**SECOND OPINION AND
RECOMMENDATIONS ON
VIE/86/016**

BY ULF STRENGER;

FREDRIK SETTERWALL KONSULT AB, SWEDEN

1992-08-24

Distribution of utilities

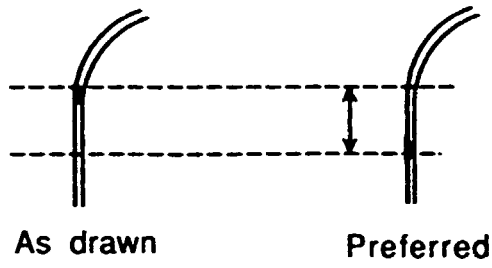
The different sizes of the pipes in different rooms reflect the consumptions in each room. Therefore the recommendations of PTE should be followed. The vacuum pipe in 09 should be 50 mm as in the other rooms. Demineralized water should be used in the lab and in the steam generator.

4. ILLUSTRATIONS

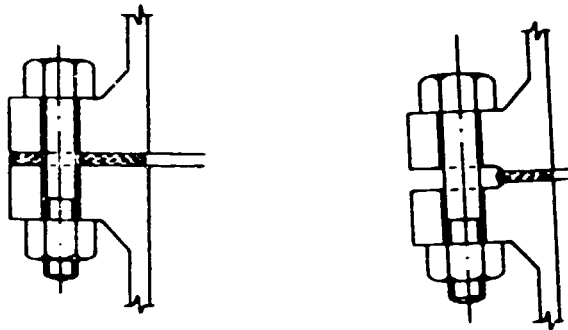
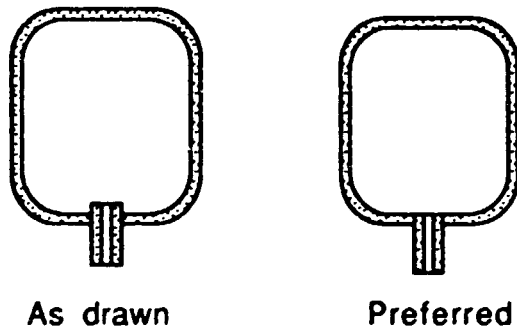
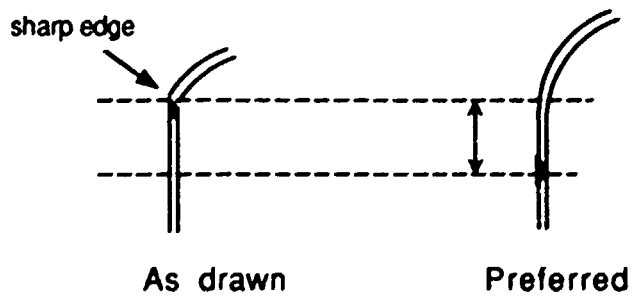
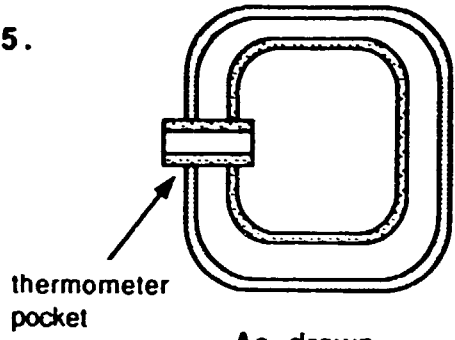
7. The packings have to be placed as described in the illustrations.
8. The outlets of the vessels must be smooth. See illustrations.
9. The shape of the vessels should be smooth. See illustrations.
10. Finish/stroke/polish rough surfaces as welds, to be the same level of finish as of the original stainless steel plate material. The material must be protected so that the quality of the sheets is preserved.
11. If thermometer pockets has to go through a jacket, it should be drawn as in illustration.
